**JOINT REGIONAL PLANNING PANEL  
(Sydney East Region)**

<b>JRPP No</b>	<b>2014SYE066</b>
<b>DA Number</b>	<b>DA93/14</b>
<b>LGA</b>	<b>North Sydney Council</b>
<b>Proposed Development</b>	<b>Stage 2 Development: 16 storey mixed use building with basement parking</b>
<b>Street Address</b>	<b>20 Atchison St Leonards</b>
<b>Applicant / Owner</b>	<b>Arkhouse Group Pty Ltd</b>
<b>Submissions</b>	<b>Nil</b>
<b>Recommendation</b>	<b>Approval with Conditions</b>
<b>Report by</b>	<b>Lara Huckstepp, Executive Planner</b>

**EXECUTIVE SUMMARY**

### 3. Building Height / Consistency with Stage 1 Envelope Approval

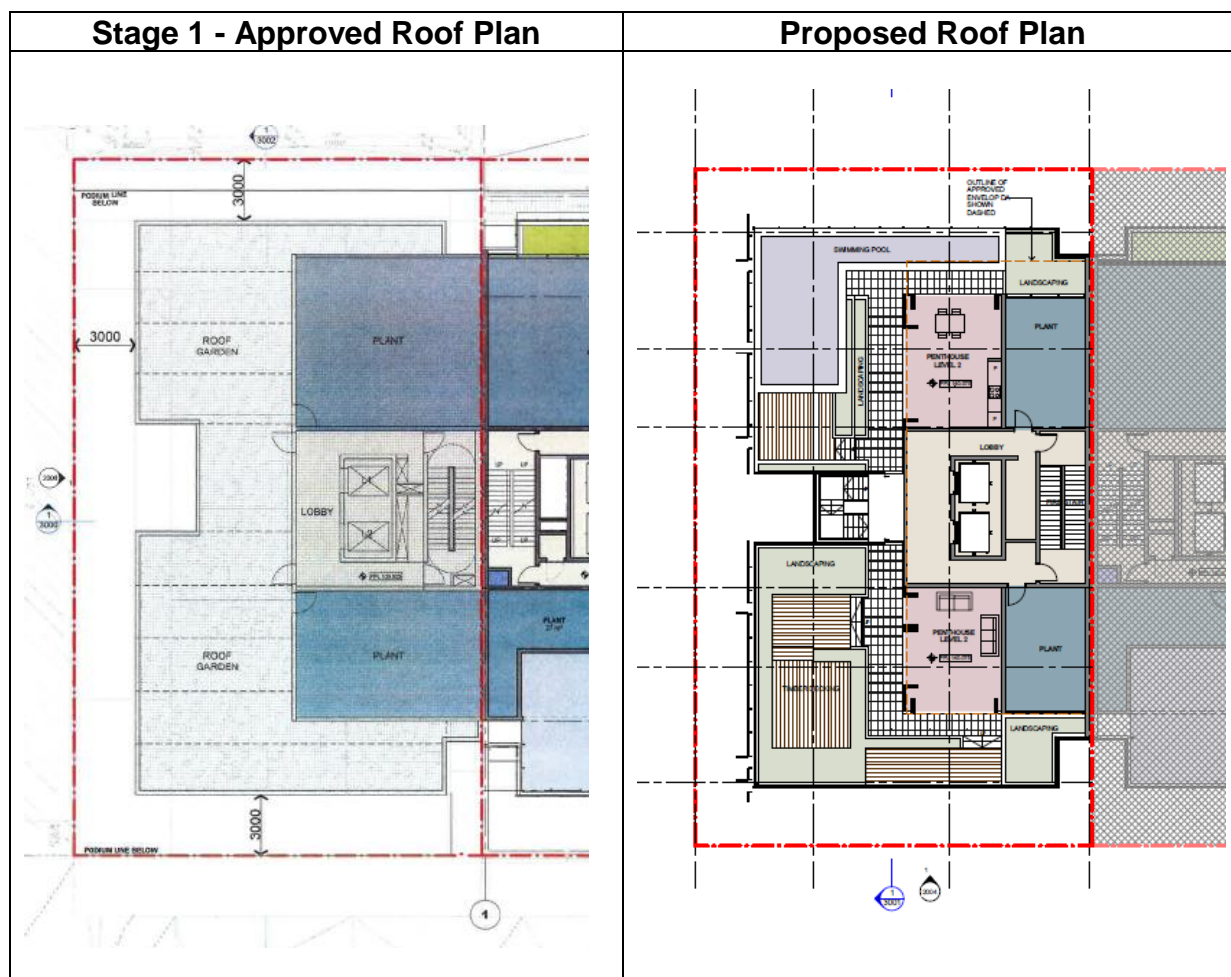
The Stage 2 DA proposes the use of the roof level (Level 15) structures to form part of the private penthouse, with no communal facilities available to the building's occupants. In detail, part of the approved plant room is proposed to be used as residential living space, and a swimming pool and a terrace will replace the approved communal garden. Photovoltaic skylight panels are proposed over the roof structures. The compliance data and plan comparison are detailed below:

Council advised the applicant that use of the rooftop structures as a residential level was not supported and also requested a Clause 4.6 request for variation was submitted having regard to the non-compliances. The applicant provided the following response:

However, Council contends that the rooftop structures were approved as communal open space and were supported as such on this basis. The applicant outlined within the Stage 1 DA Concept Plan that this roof level was proposed as a communal open space and outlined within the submitted SEE as follows:

It can be clearly seen that the rooftop structures were only proposed and subsequently approved as communal facilities and comprised only a roof garden. Importantly, the development application has been lodged as a Stage 2 DA and Section 83D of the Environmental Planning and Assessment Act relating to staged development applications and consents Clause (2) sets out that:

Those elements that include the plant room and the upper level of Level 14 have been considered under the Stage 1 building envelope approval. Those new elements that were not approved as part of the Stage 1 Envelope Approval include the change of use of the plant room to residential use, the swimming pool, terrace as well as photovoltaic panels.

The Clause 4.6 Objection is not supported for the use of Level 15 as a residential level. The breach of the proposed residential level would be at least 5m, contrary to the 3m maximum breach currently being considered under the planning proposal with the Department. A condition is recommended to be imposed to require the use of Level 15 to continue to be a communal space. Subject to this condition, the breaches caused by the rooftop structures can be supported. It is noted that the use of any structure is an important consideration together with its built form.

The use and layout of Level 15 was approved as a communal area as part of the Stage 1 DA. The Stage 2 DA now proposes to use the level as a residential level which is not supported. This level was approved in concept to contain plant and a rooftop garden for communal use. The change of use to this level as a residential level would require the modification of the Stage 1 DA in any case, however would be unlikely to be supported given its exceedence with Building Height. A condition of consent is recommended to be imposed to require Level 15 be used as communal area consistent with the Stage 1 development consent.
